**ADDENDUM TO THE CONTRACT
for the
Juneau International Airport (JNU) Cargo Hardstand**

Contract No. BE17-035

ADDENDUM NO.: ONE - REVISED

DATE ADDENDUM ISSUED: July 22, 2016

Barricade Location Clarification

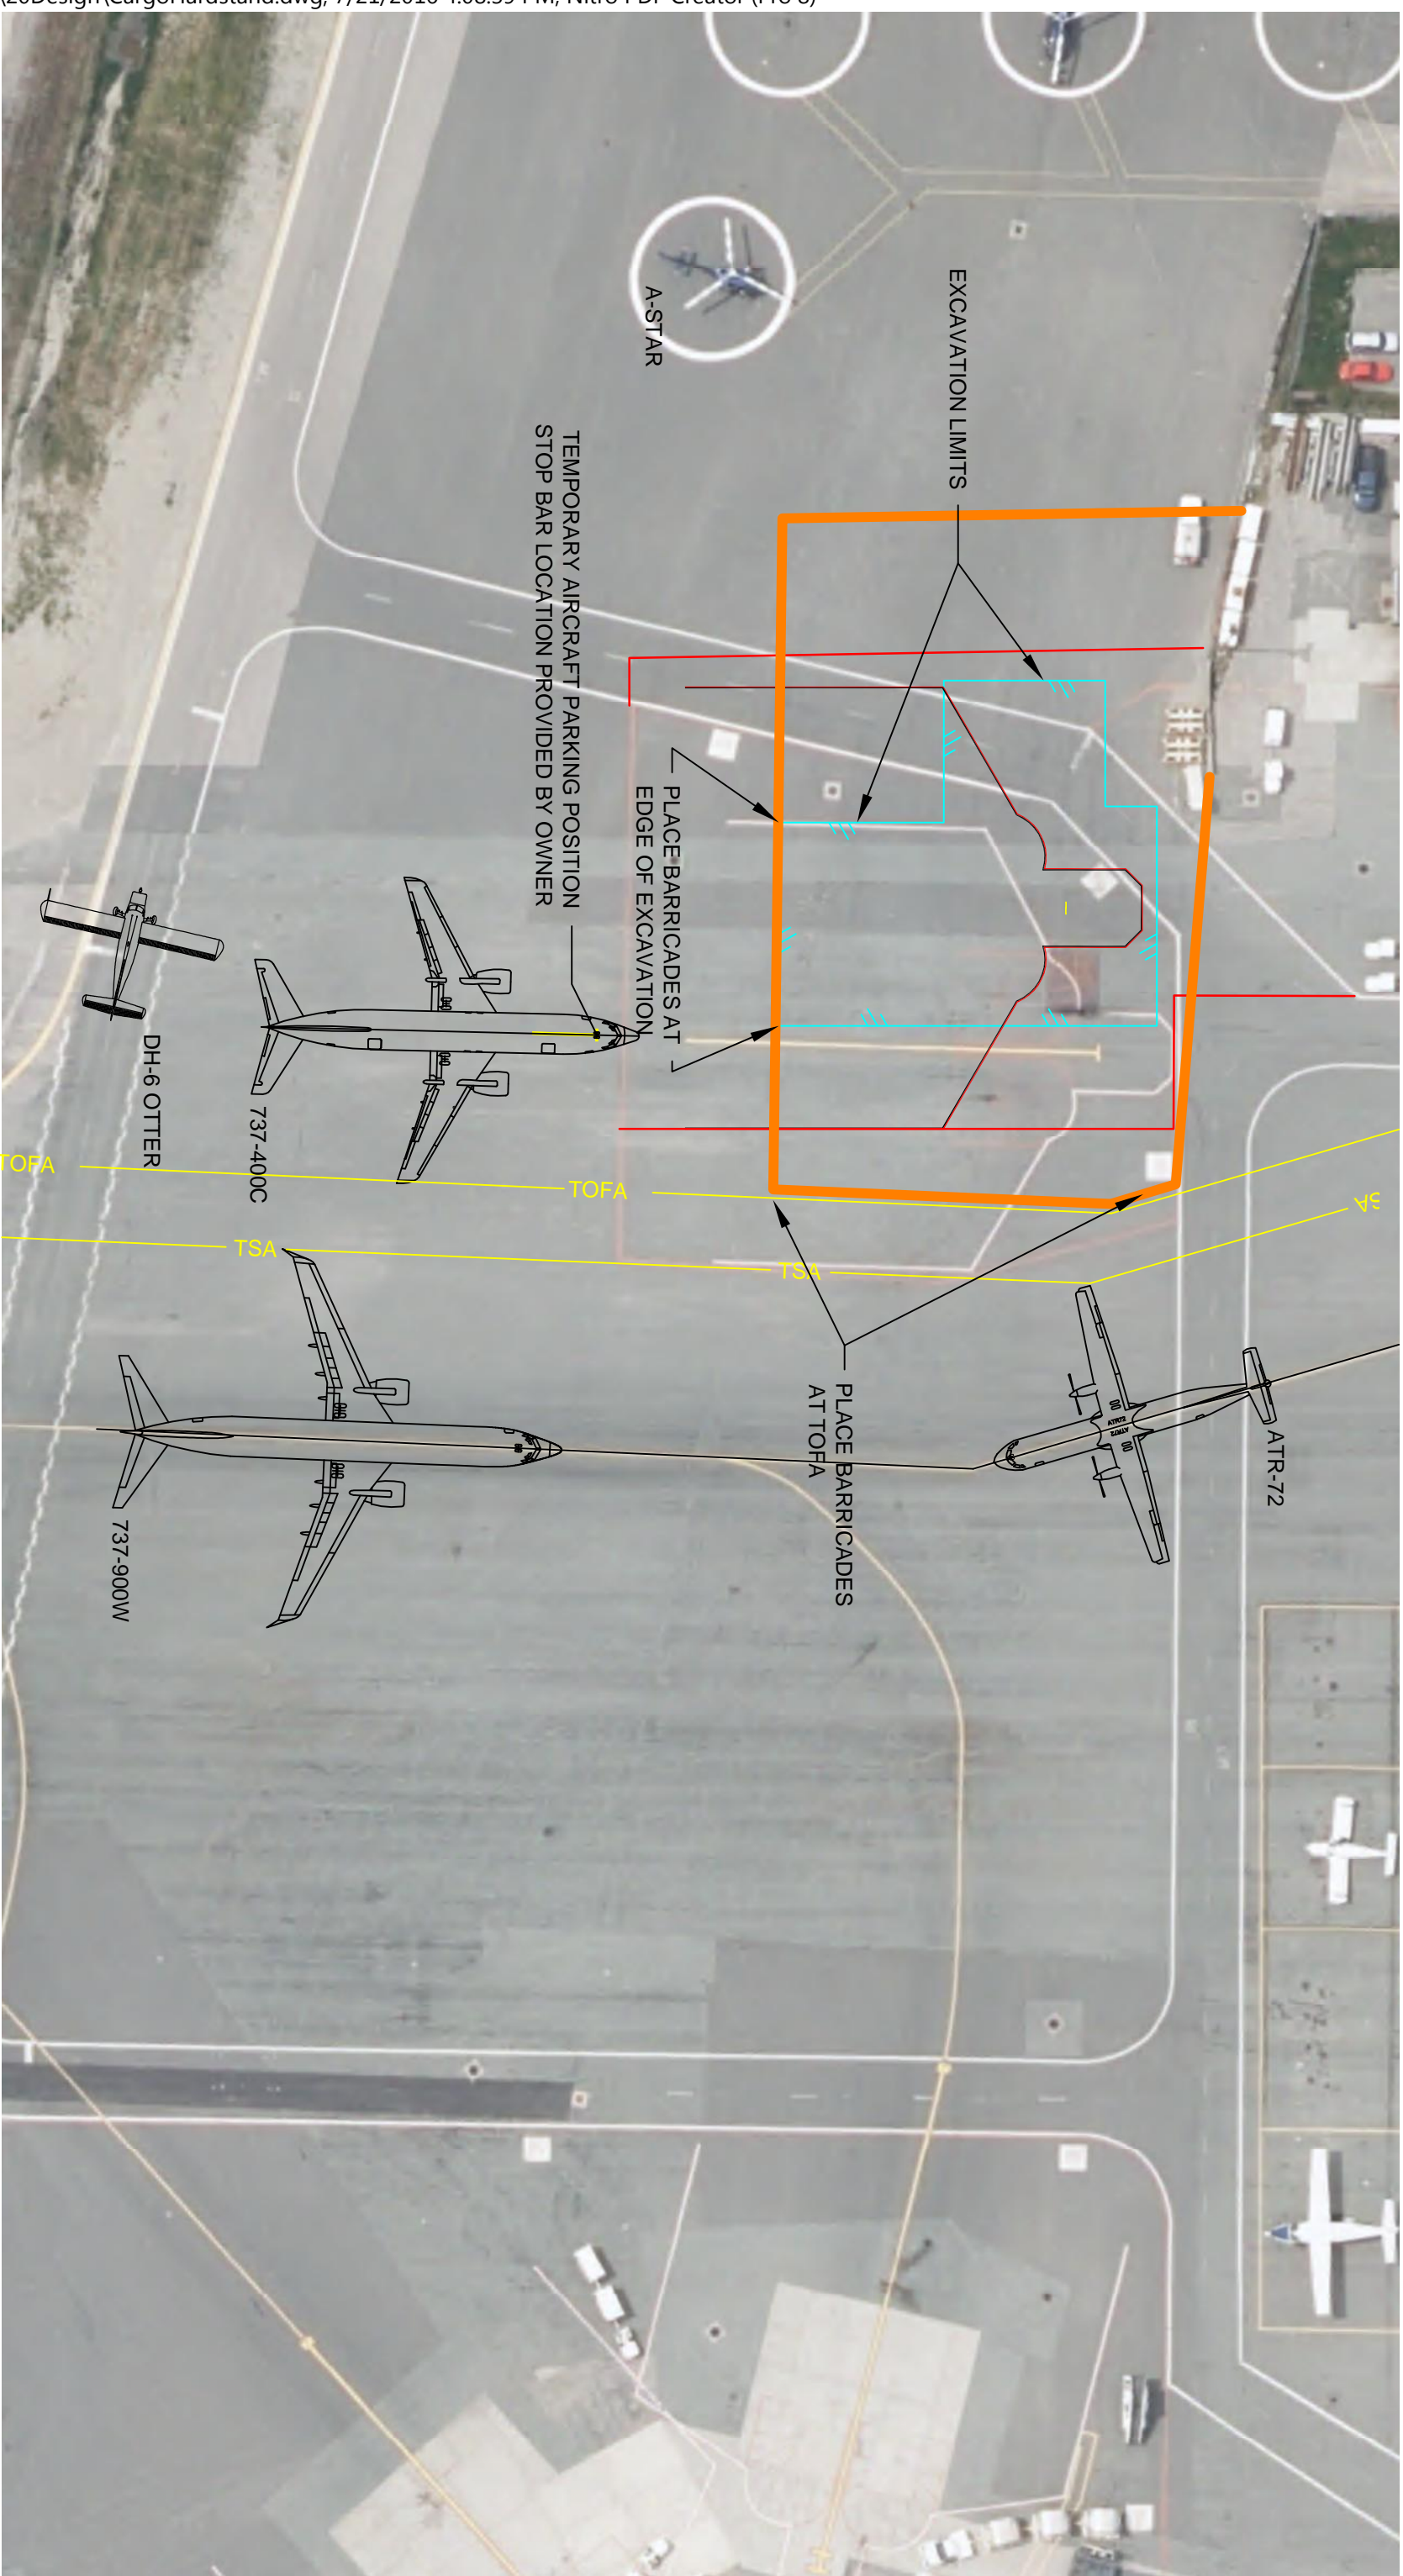
- Item No. 1 SHEET 4 - PROJECT LAYOUT AND GENERAL SAFETY PLAN, **Reference** attached figure entitled "Barricade Location Clarification" for placement of hazard marker barriers.
- Item No. 2 SHEET 10 – TEMPORARY MARKING PLAN, Coordinate table may be used for dimensional **reference only**. Coordinate point 248 (Termination Bar) will be provided in the field by the Owner.

Striping Clarification

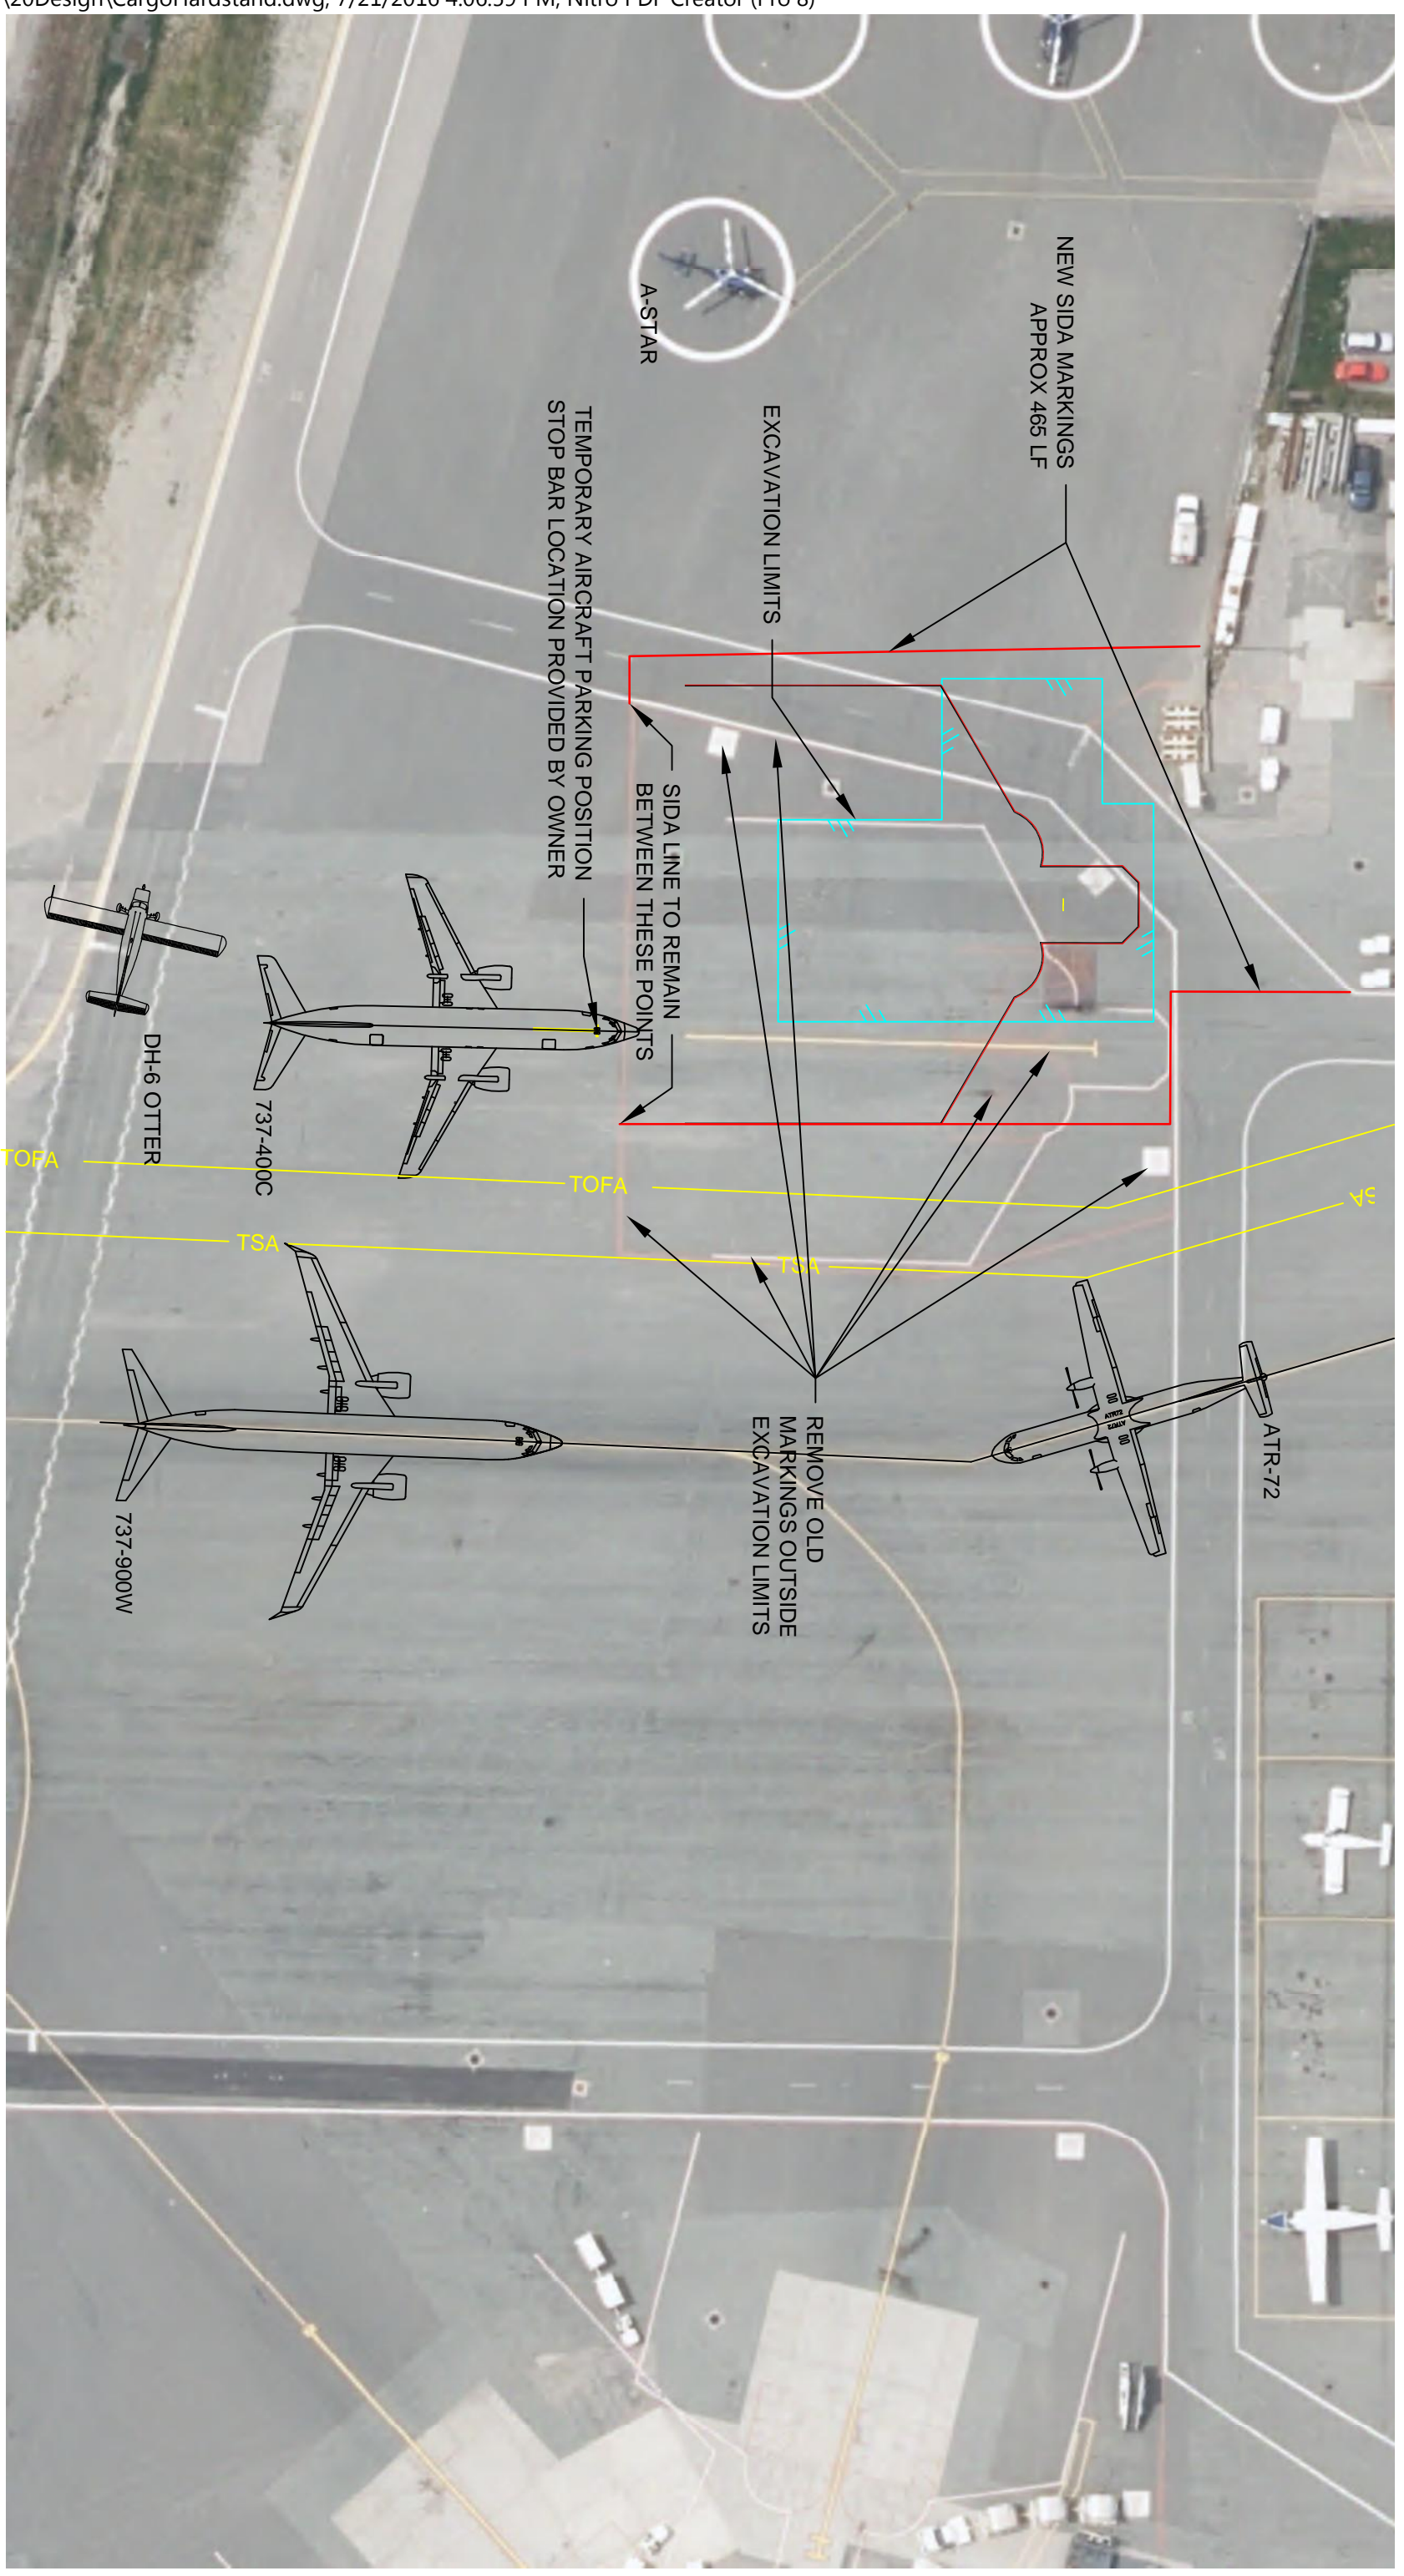
- Item No. 3 Sheet 11 – PERMANENT HARDSTAND MARKING PLAN, **Remove** coordinates 220-223. Owner will provide locations for new SIDA boundary line and SIDA Markings. See attached figure entitled “Striping Clarification” for approximate location of new SIDA markings and approximate location of markings for removal.
- Item No. 4 Sheet 13 – TUG ROAD MARKING PLAN, Coordinate table may be used for dimensional **reference only**. Alignment will be provided in the field by the Owner. See attached figure entitled “Striping Clarification” for approximate location of new SIDA markings and approximate location of markings for removal. Add note to sheet.
